**To:** Harris, Michael[harris.michael@epa.gov]  
**Cc:** Dee.allen@ldftribe.com[Dee.allen@ldftribe.com];  
lwawronowicz@ldftribe.com[lwawronowicz@ldftribe.com]  
**From:** Hanson, Kristen  
**Sent:** Mon 5/8/2017 4:31:34 PM  
**Subject:** FW: Groundwater modeling Data

Thanks for reaching out to discuss the reason why Tribal professional staff are reluctant to share certain modeling data, regarding the Haslell lake LUST site, that was generated by EPA's contractor. As you and I discussed on April 14, quality controlled, properly handled, and analyzed groundwater and soil sampling data should not be subject to claims of confidentiality, but should be openly disclosed and used to determine the nature and extent of contamination. However, that is not the issue that we are currently dealing with at the Haskell lake Site. It is not a question of whether quality data should be released, it is a question of whether a potentially inaccurate and non-representative computer generated model should be used as the basis for remedial decision-making.

## **Model 1**

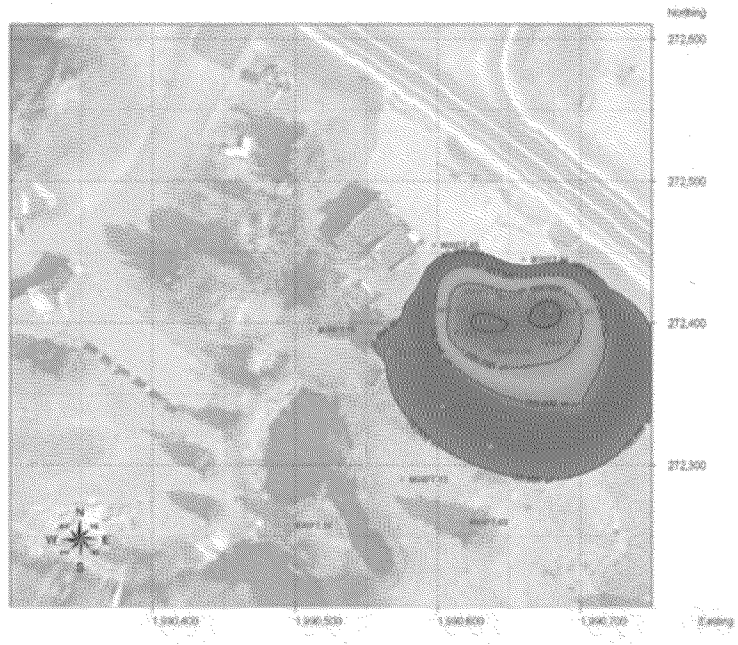
The plume shown in model 1 is based on the incomplete data set and extends further to the east than existing data suggests, does not account known site data, and does not show the plume path from the source area to the lake including the MW16 well nest.

Tower Standard Site  
Lac du Flambeau, Wisconsin  
Data Analysis and Data Visualization Report  
September 2016

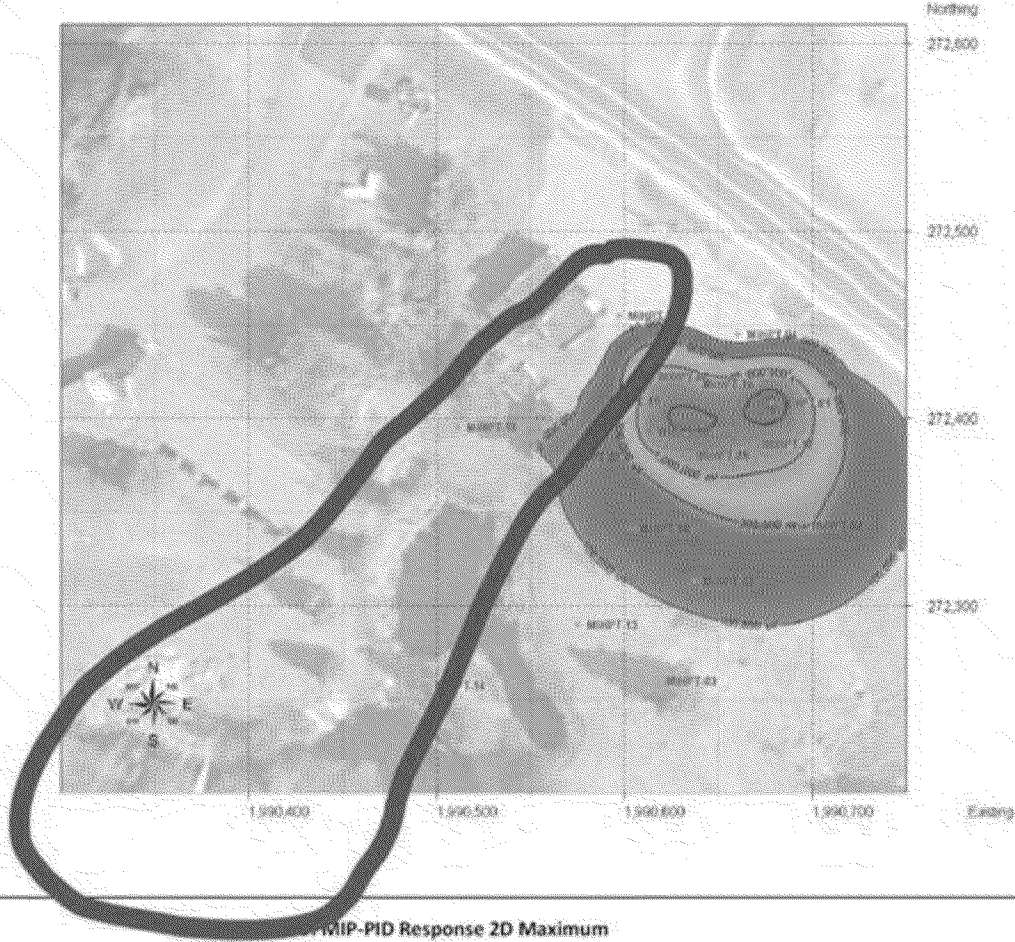
The Area in red is known substantial contaminated groundwater plume, and is not included or represented in the graphic representation.

It was our understanding that the model was being updated to include all data (including the known plume area) and would not be ready until the week after Thanksgiving.

## **Model 2**

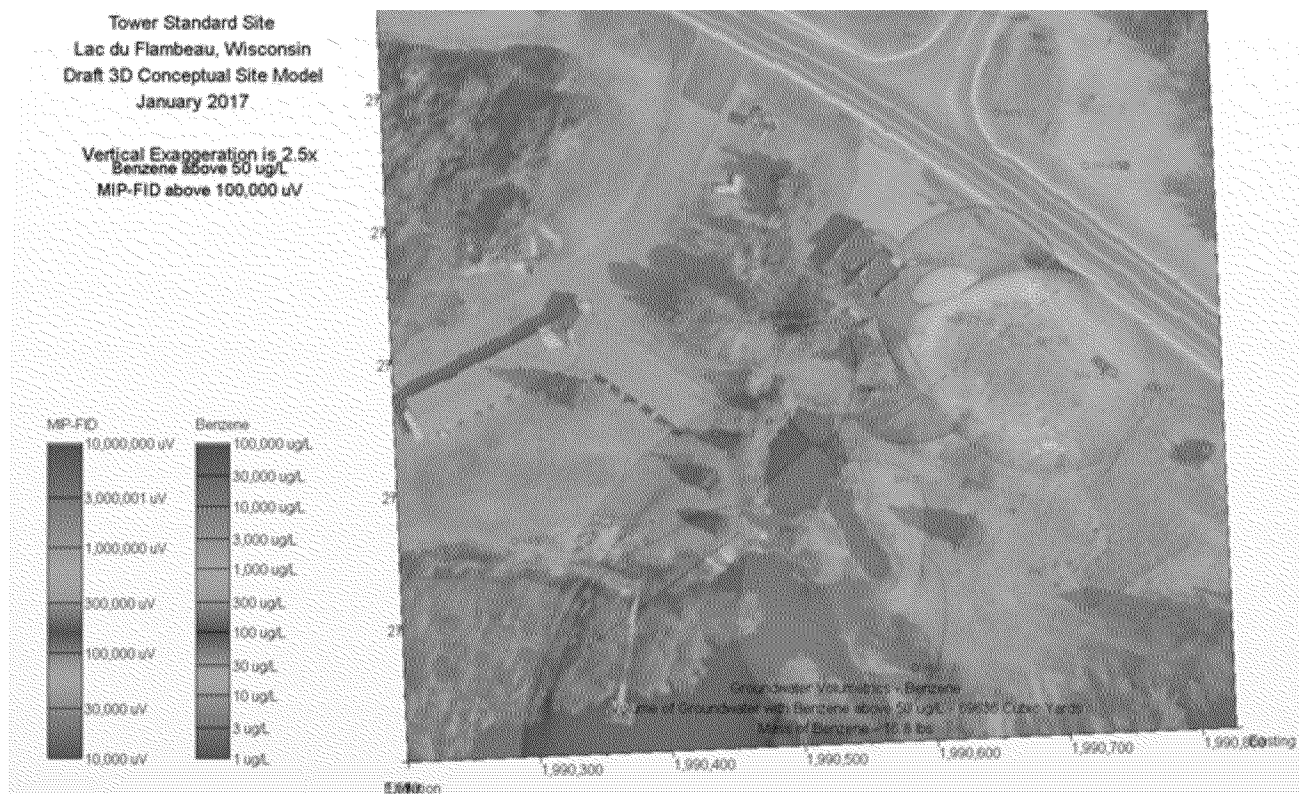
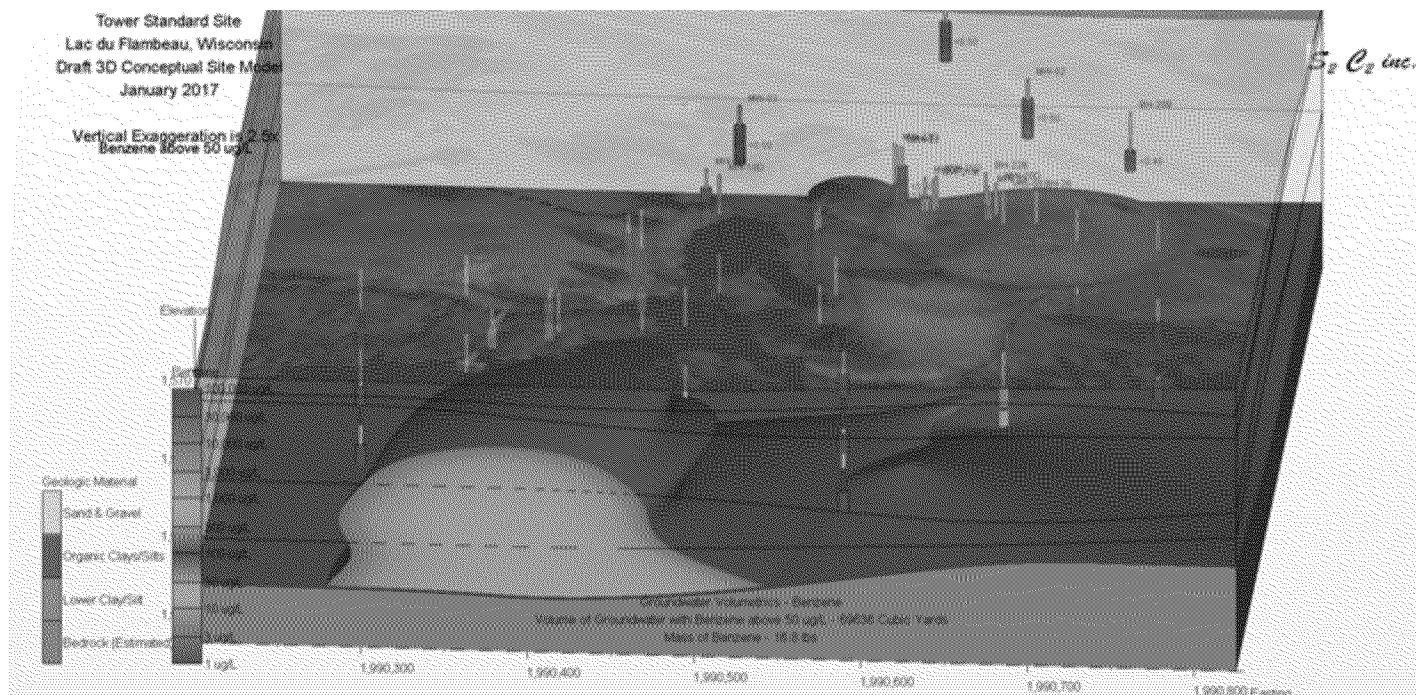
This model shows two separate plume, one near the road, and a separate plume near the lake rising from the bedrock. In many places, the model does not represent actual site data and extends the plume to the east in areas of known clean areas.

Tribal Comments include model extends further to the east than data supports

Model 2 shows 2 separate plumes, one near the road and one rising from the bedrock near the lake. This interpretation is not likely and different than what reasonable data interpretation suggests.
